APPLICATION NUMBER: RECON 24/0756

PROPOSAL: 30NO AFFORDABLE HOUSING APARTMENTS AND ASSOCIATED EXTERNAL WORKS AND PARKING

SITE: Land Formerly Known As 21 Kelvedon Street Newport

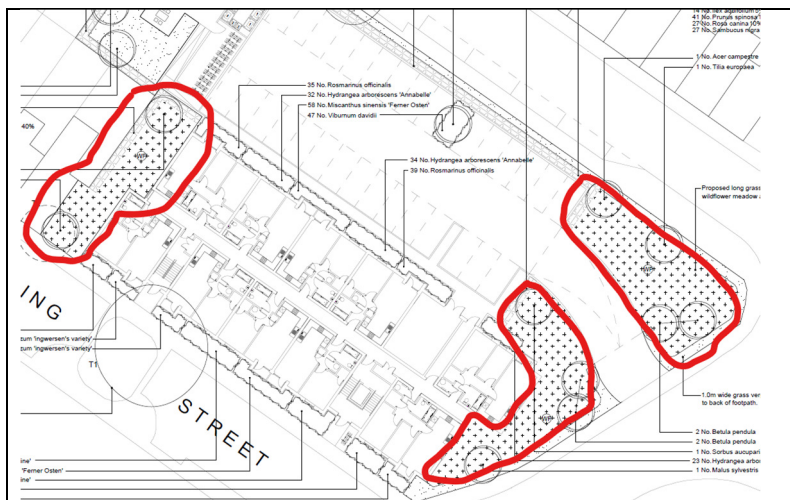
The impact of the proposals on the street trees needs professional arboricultural consultant input and the proposal needs to be referred to the Tree Officer. There will be impacts on category A and B trees, some already compromised as they are in tarmac. In addition T1 will require crown reduction as the crown spread extends beyond the building line as shown below, note this is not accurately shown on the Site Plan.

Very large areas (highlighted in red above) are proposed to be seeded at a low rate with a meadow mix for wetlands. There is no indicative drainage strategy, rain gardens are mentioned in the application but not shown on any plans. The wetland mix treatment is extensive, risky, and will appear out of character in the urban context.
